Newlin Gulch Major Drainageway Plan - Draft

Baseline Hydrology

RE: Newlin Gulch MDP & FHAD
Final Baseline Hydrology Report
Agreement No. 12-09.02

Newlin Gulch Major Drainageway Plan
Figure B-1: Hydrology Map
 March 2015

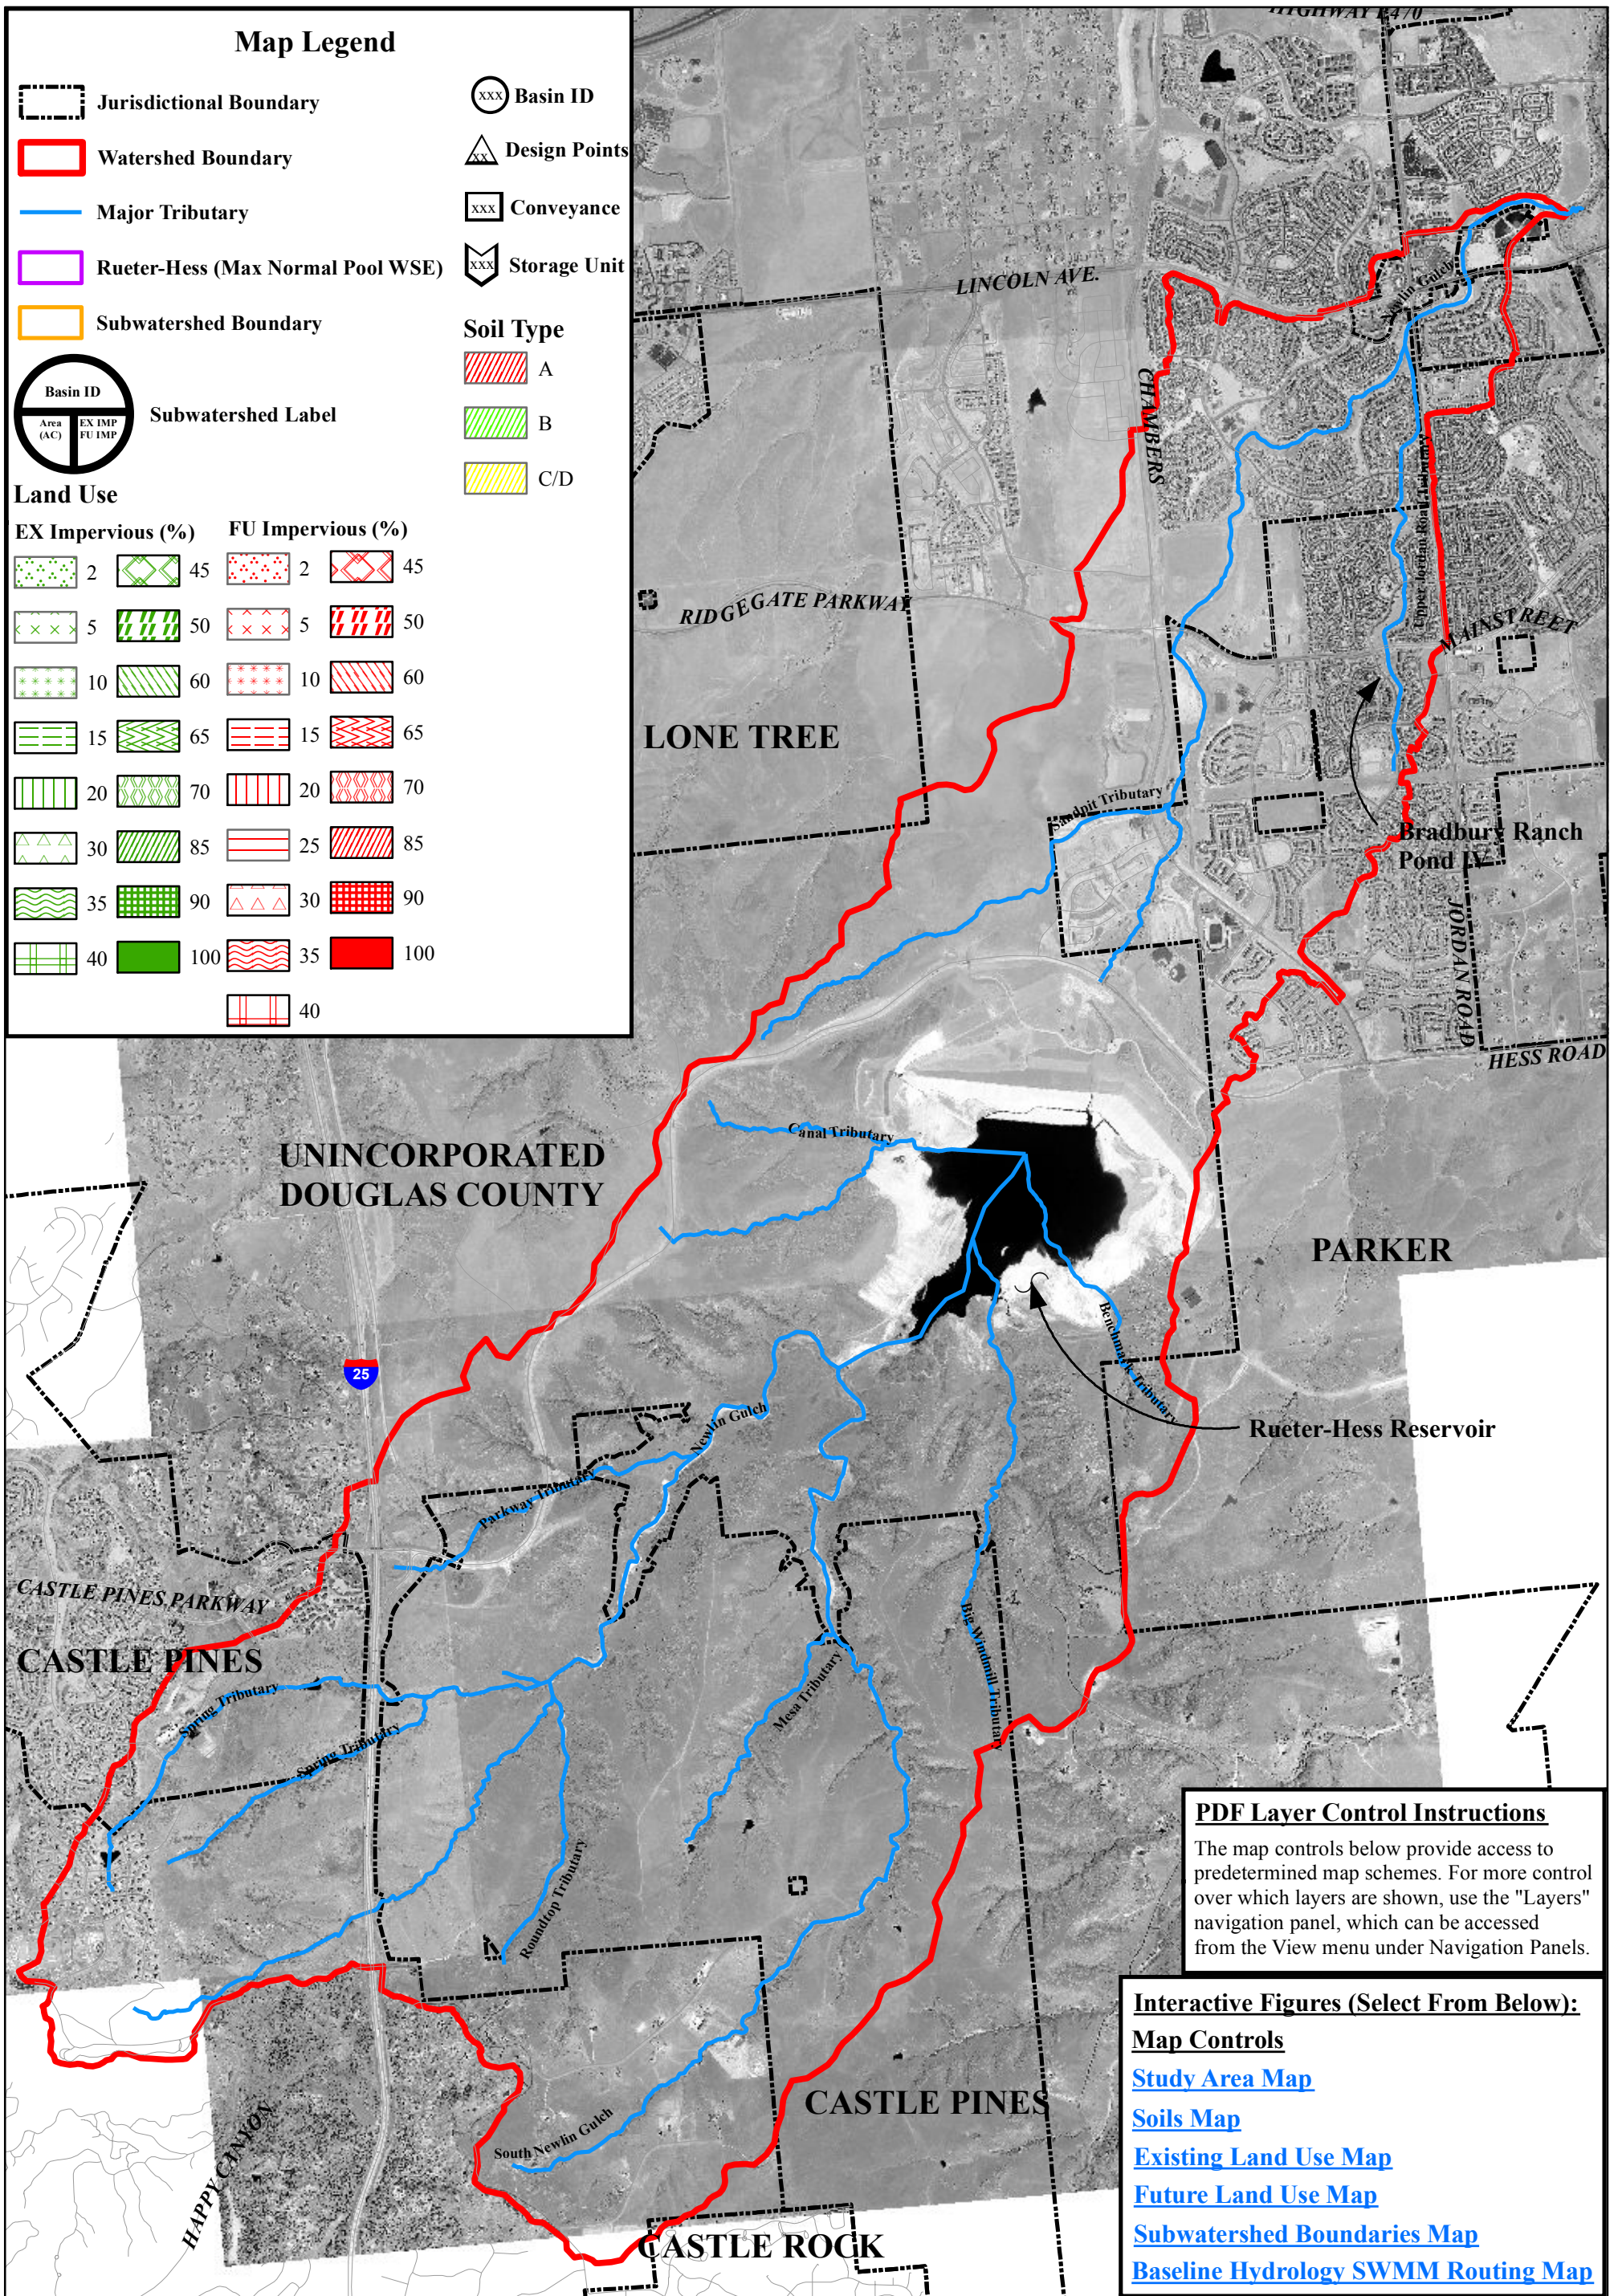
Figure B-1 [Several inconsistencies were noted between future impervious values shown on the subwatershed map and values listed in Table B-2, CUHP Input]
All inconsistencies have been corrected; this may have resulted in minor changes to future composite impervious values for some subwatersheds.

Figure B-1 [Re: Future Land Use, Newlin Crossing development area north of Mainstreet, shown as mixture of 10%, 45%, 70% impervious]

- Change everything east of Newlin Gulch to 45%
- Change everything west of Newlin Gulch to Chambers to 70%

Figure B-1 [Re: Future Land Use, Meridian development west of Chambers Rd, north and south of Mainstreet]
This area does seem too high. I looked at the PDs for Meridian International Business Center and Sierra Ridge. The area currently shown as 75% is more likely to be around 60%. *Future impervious for Meridian has been updated to 60% as requested. The small corner of the watershed that lies within the City of Lone Tree was changed to 70% to match future land use values used for the adjacent areas in the 2012 Happy Canyon Creek MDP.*

Impervious values have been updated as requested based on recent development plans. Future development CUHP/SWMM models have been re-run; peak flows and all associated tables and figures updated.
